SECTION 009113 – ADDENDUM ONE

- A. Project Name: 22034.02 Meridian High School Additions, Renovations and Ballfield Rebid
- B. Owner: Meridian Public School District, 1019 25th Avenue, Meridian, MS 38391
- C. Architect: Dale | Bailey, an Association, One Jackson Place, Suite 250, 188 East Capitol Street, Jackson, MS 39201-2100
- D. Architect Project Number: 22034.02
- E. Date of Addendum One: 5 January 2024

1.4 REVISIONS TO DRAWINGS

C-403
Geometric Plan - East
Sidewalk

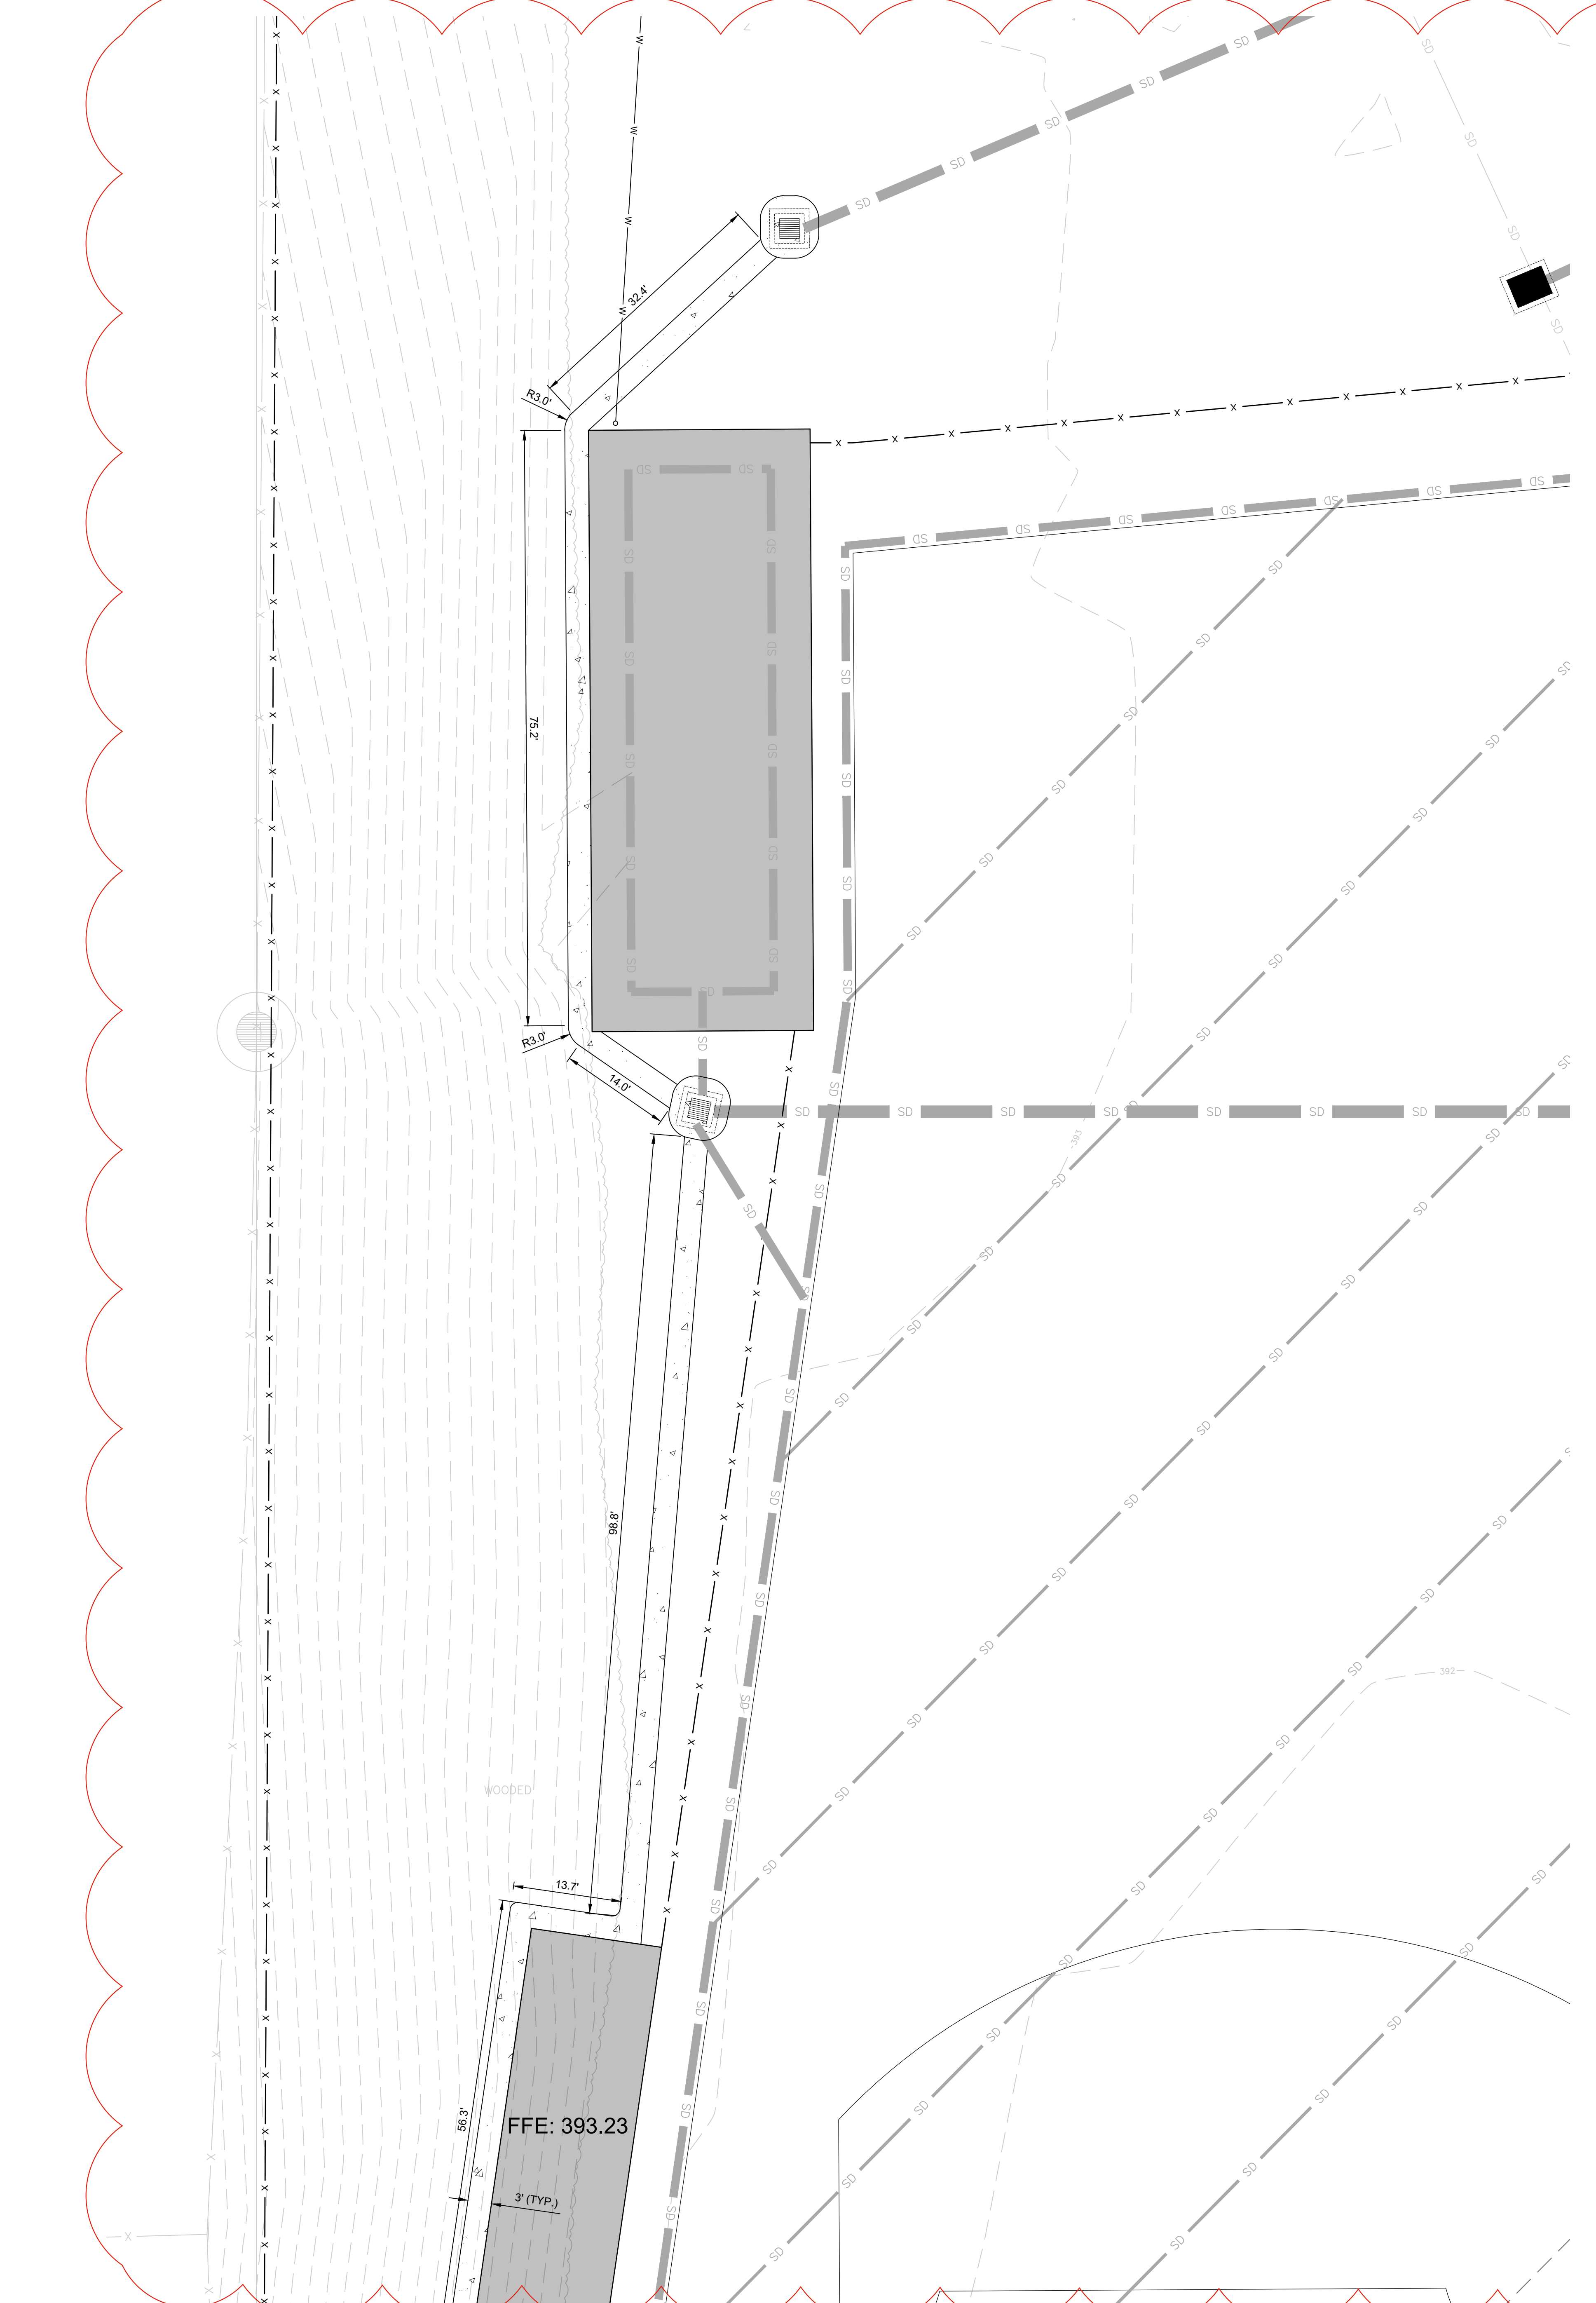
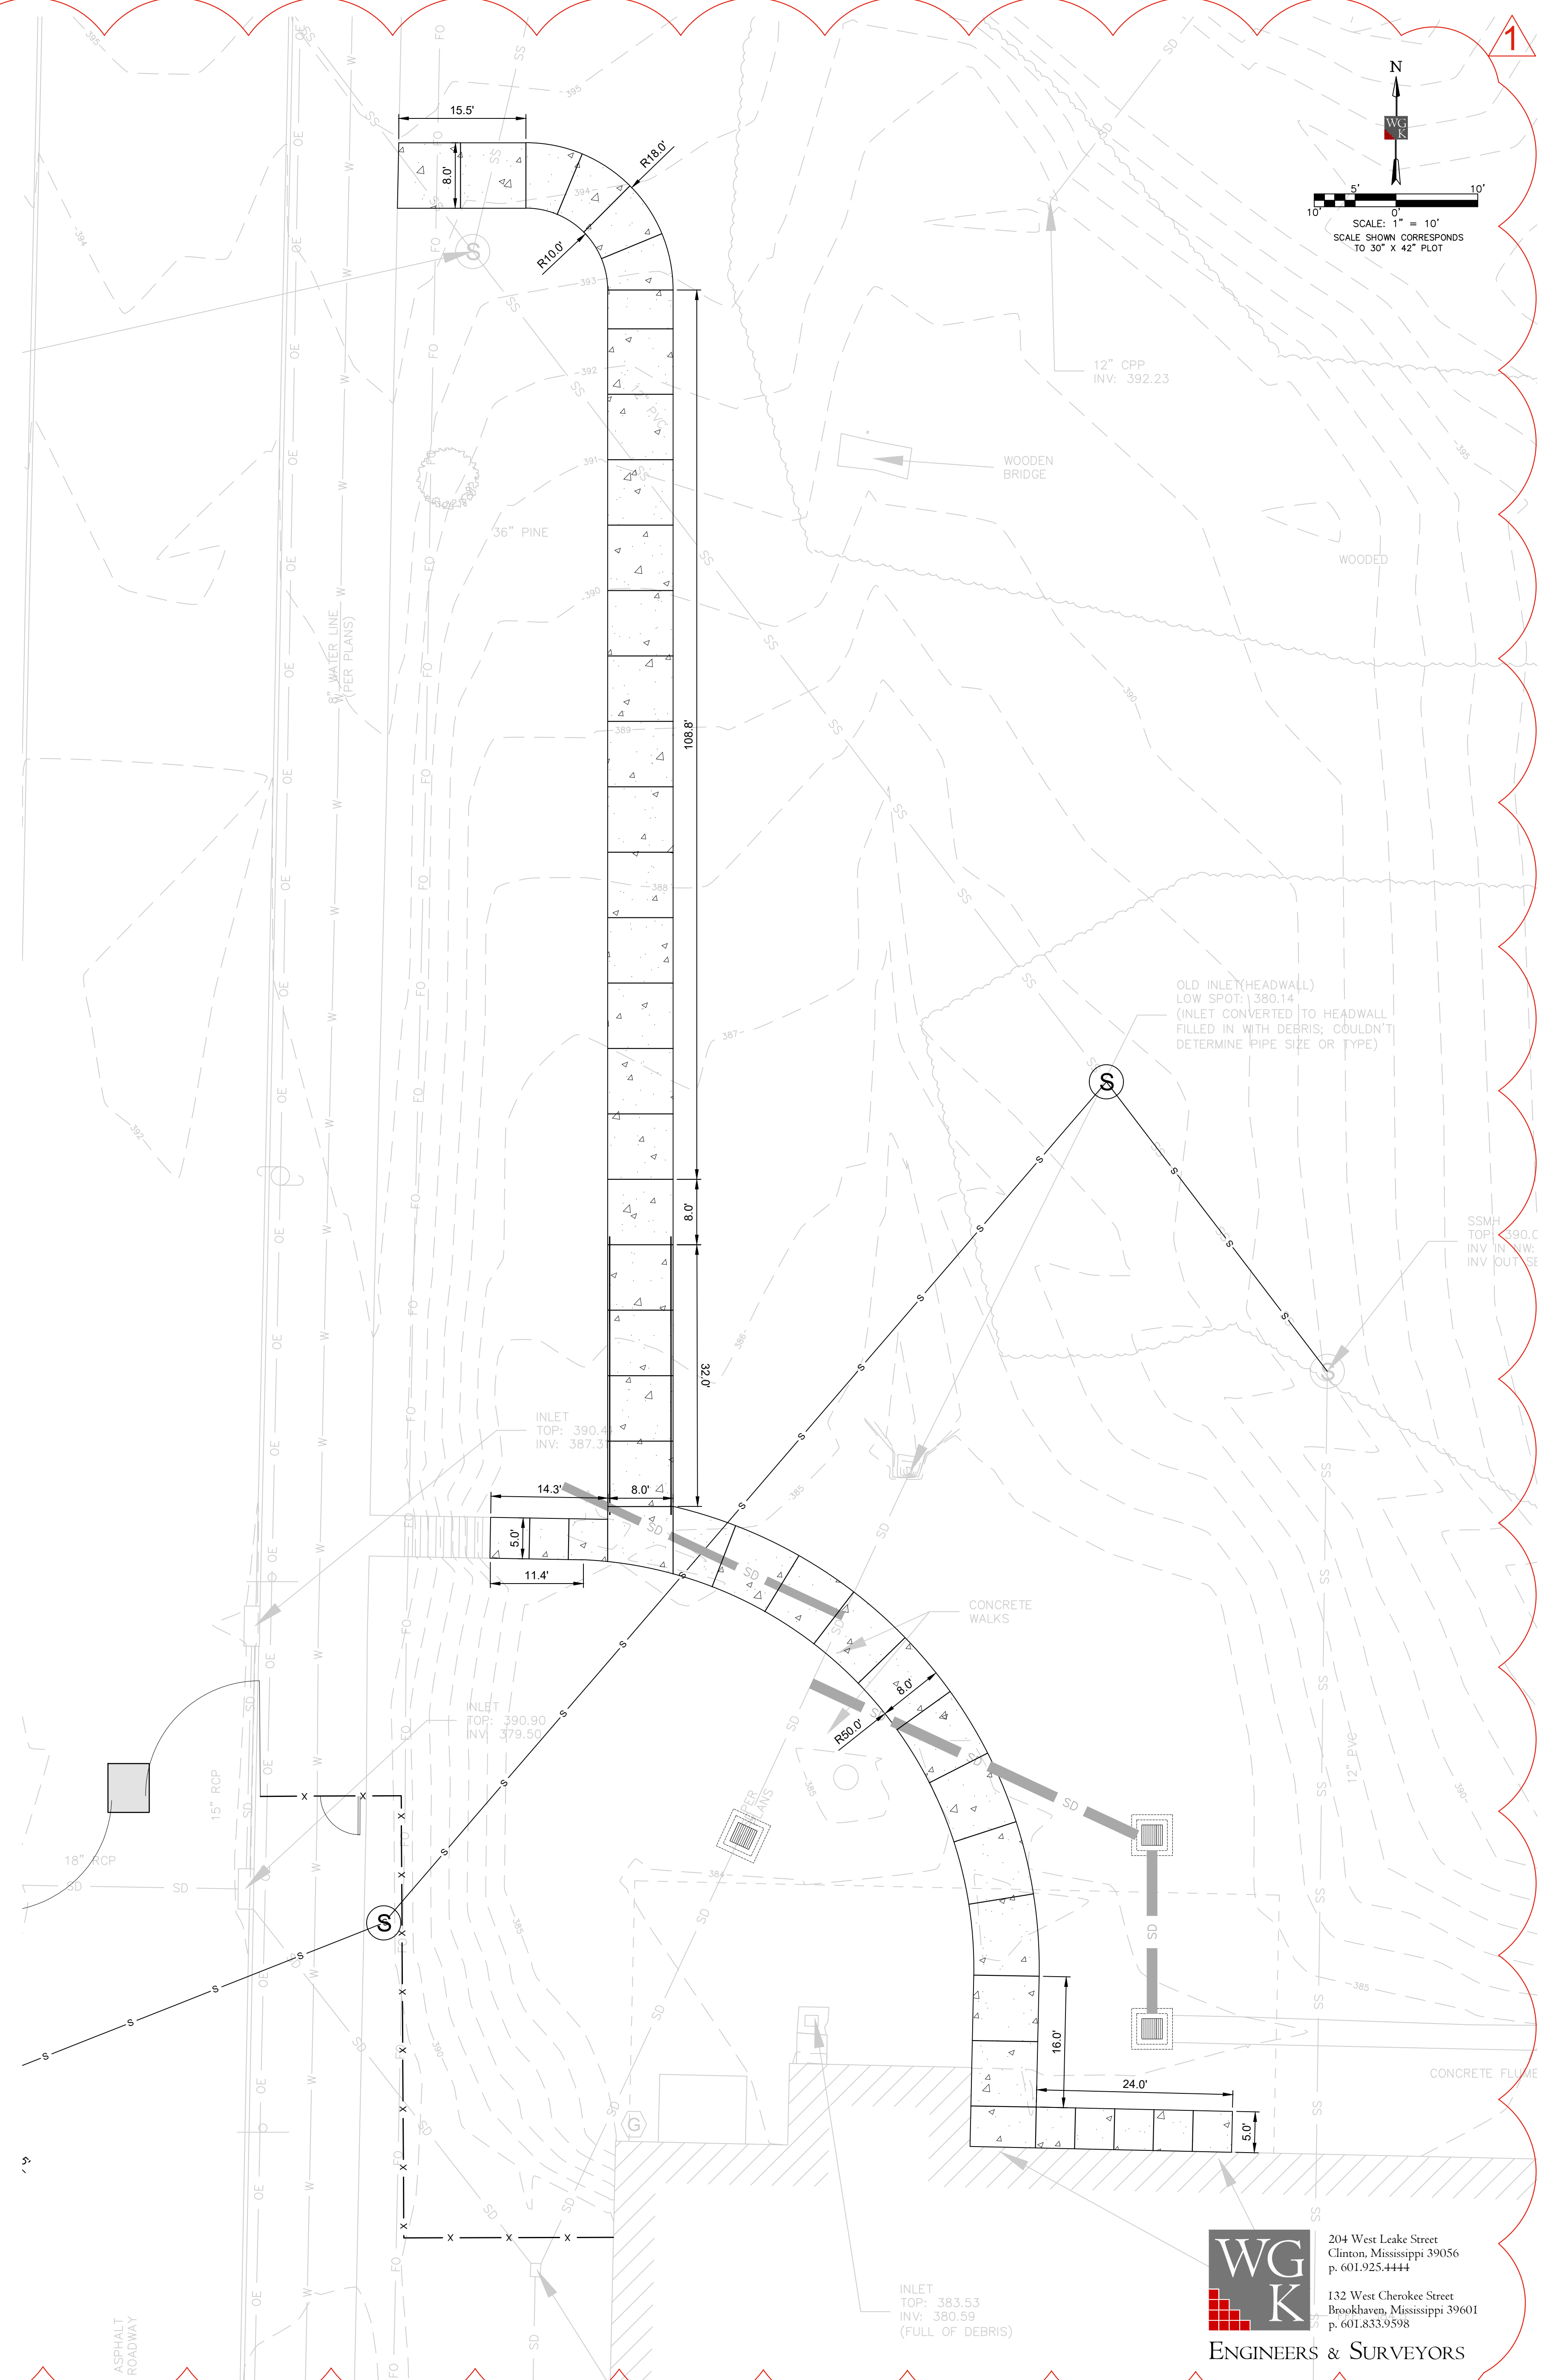
- L. Sheet C-402 (New). Added to reflect dimensions/layout of work at baseball area
- M. Sheet C-403 (New). Added to reflect dimensions/layout of work at baseball area
